January 24, 1975
C1-750-33/COM PROGRAMS
10-35-00-05
AOL 10-742A

Subject: PASSENGER OXYGEN SYSTEM MAINTENANCE, DC-10

Applicable to: All DC-10 Passenger Aircraft

SERVICE SKETCH REV. *1-24-75*

III. HARDMAN DOOR REWORK

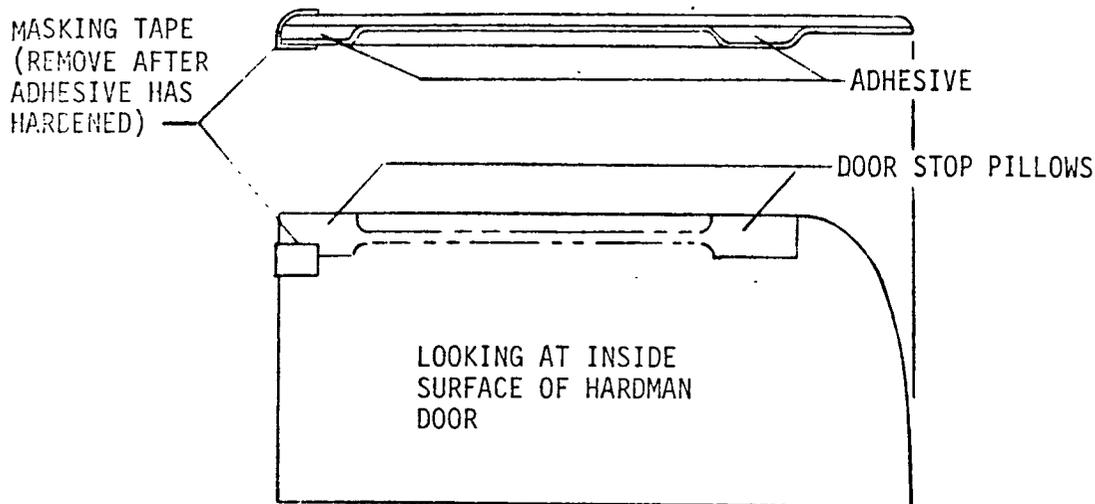
- A. Fill flush door stop pillows on Hardman seats only using epoxy adhesive or equivalent rigid filler.

NOTE: It is suggested that masking tape be placed on adjacent door faces to prevent adhesive from defacing door.

- B. Adams Rite

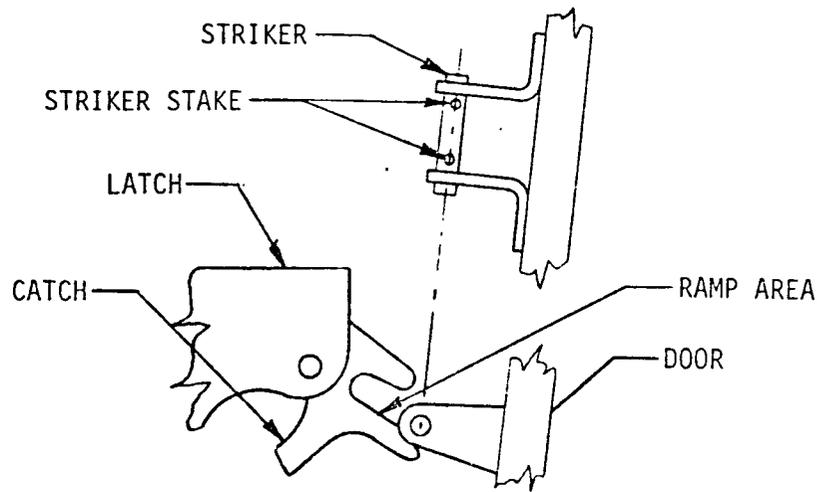
The striker shall be parallel to the top of the door. The latch catch shall be normal to the plane of the door stops. The striker shall approach the latch catch and contact the catch in the ramp area as shown below. The catch shall not contact the staked area of the striker and the

striker shall not contact any portion of the body (or spring) of the latch in any position of the door including side play (see sketch below).

FIGURE I

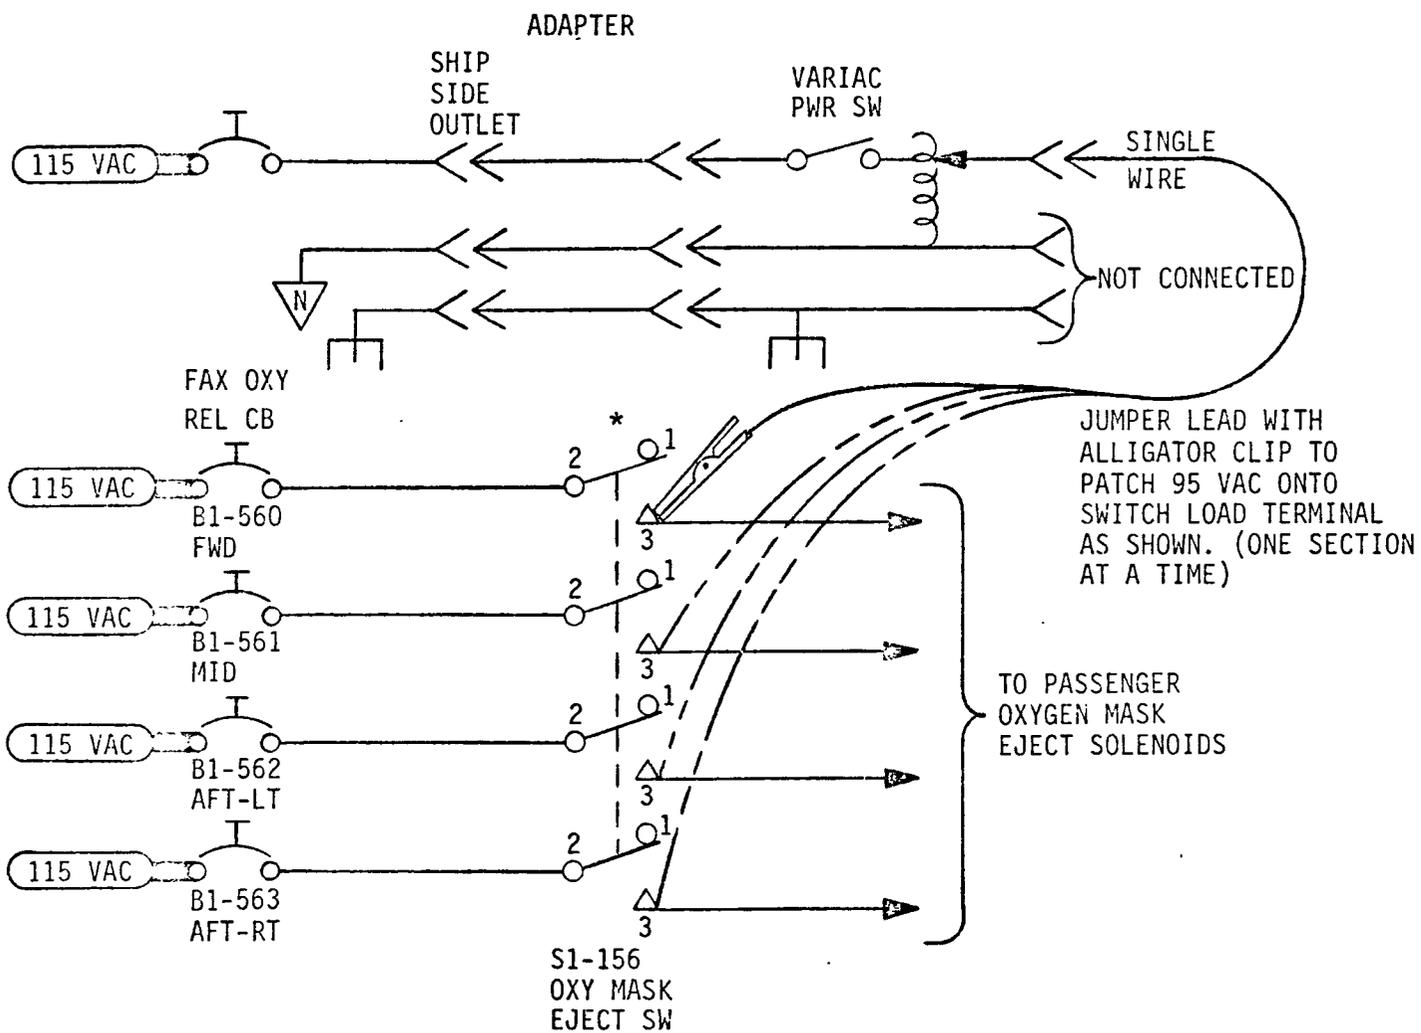
- A. Add restraint to all oxygen compartment doors to prevent full opening and inadvertent generator firing.
- B. De-energize the four "PAX OXY REL" circuit breakers located on the Flight Engineers circuit breaker panel.
- C. Set up the electrical test circuitry shown in Figure 1, Page 6, Connect the power jumper lead from the VARIAC to the respective section switch screw terminal as noted below:

S1-156 D3 Fwd. Pass. Section
 S1-156 C3 Mid. Pass. Section
 S1-156 B3 Aft left Pass. Section
 S1-156 A3 Aft right Pass. Section

- D. Verify VARIAC is set at 95 VAC, 400 HZ.
- E. Apply power for 3-5 seconds.
 NOTE: Apply power only once.
- F. Record by location those doors which failed to deploy.
- G. Door Pull
 - 1. Pull on any door which failed to open.
 - 2. If the door opens and the latch has released electrically, the reason the door did not open during Para. E. was due to binding of the door or latch misalignment, see Item V or VI. Proceed to Para. I. J.
 - 3. If door fails to pull open, proceed to Para. I. H.
- H. Manually unlatch all remaining doors. Electrically verify the integrity of the latch wiring from the power supply to the latch. Repair as necessary.

FIGURE II

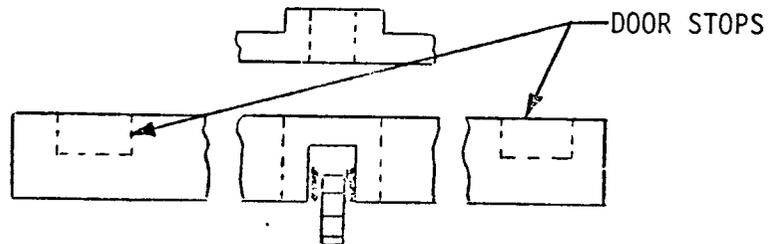
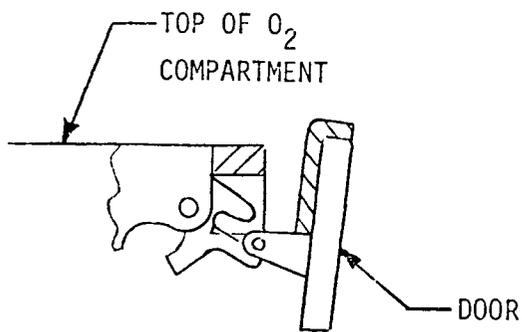
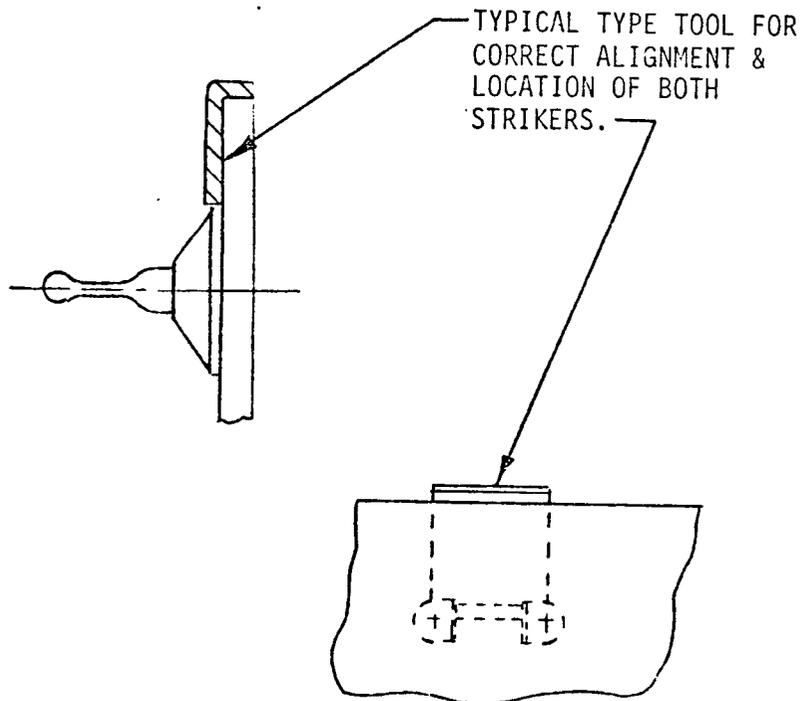
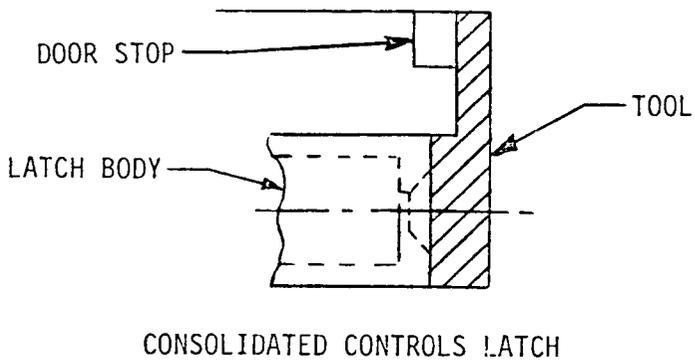
C. See sketch for typical tool aids, Page 7, Figure II

TYPICAL TYPE TOOL FOR ALIGNMENT AND CORRECT LOCATION OF BOTH LATCHES.
